## Comments for 2017 A117.1 draft for Final Resolution

42 ballots were returned. One ballot was abstain. The remainder were approve all committee actions with the following exceptions.

Table at 36" height with 3" high bottom rail.

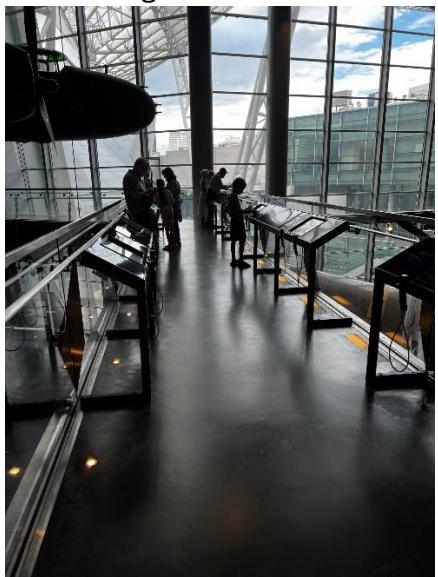
I am requesting a move back to 2017 language. This needs to be held for next cycle so that this can be addressed in a manner that is more comprehensive.

While I agree the extra height is a good idea for under stairways, making this universally required does not work for many other protruding objects. While this says 'headroom height', this literally applies to anything that is above 27" because if Section 307.2, Protruding objects.

I think any of the following configurations pictured below would stop someone from walking into them, but would not comply with the way we have the new language written. An alternative means would not comply with 10" minimum.

Following are many examples that do work that would not meet the current requirements.

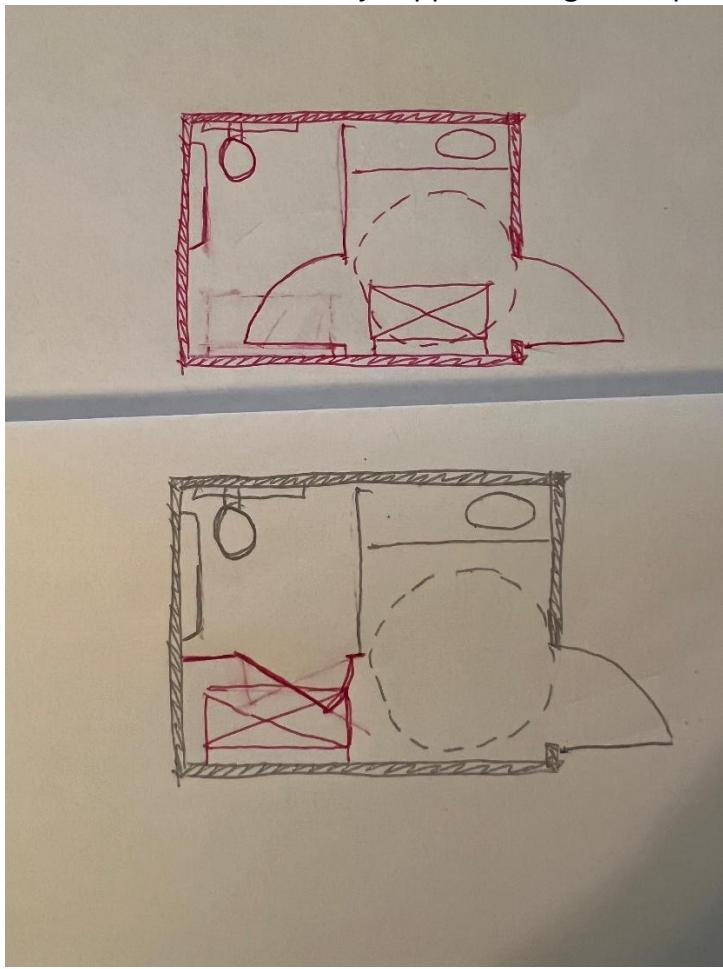
**Proposed resolution:** Too restrictive, result is they will not be provided.

**Proposed resolution:** The issue is for the one and two compartment toilet rooms. By forcing the baby changing table out of the accessible compartment into the room it will most likely adversely affect accessibility by either losing the large stall, or obstructing access for everyone. Please revert to the 2017 text so that we can address this more completely next cycle. Below is a picture that was sent to me illustrating the issue in a two compartment toiler room.

This is what will most likely happen in single compartment bathrooms.

Keep existing A117.1-2017 language.

Towel Dispensers and Hand Dryers: Operable Parts

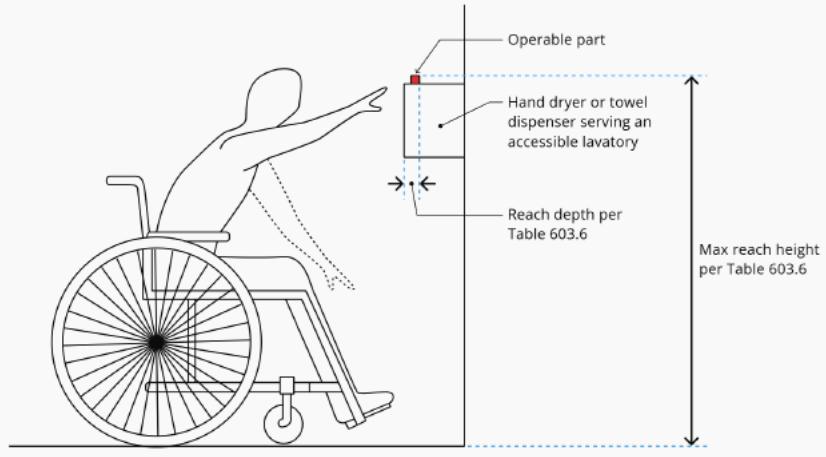
Agree with mod I suppose, but we're typically not providing a mix of PT or HD units with different operable part depths. It's typically the same unit in 2 or more locations, but the reason statements are maybe misinterpreting this table. Is the reach depth the operable part on the unit itself or the reach depth over a counter. If it is supposed to be indicating the reach depth over a counter than please provide clarification, a figure to assist, and someone tell Upcodes to revise their figure below.

I'm not sure this table is necessary or makes sense on its own, but there needs to be a figure like below to eliminate misinterpretation.

**Staff note:** The issue seems to be more with the current text rather than the revised text. The figure is not correct.
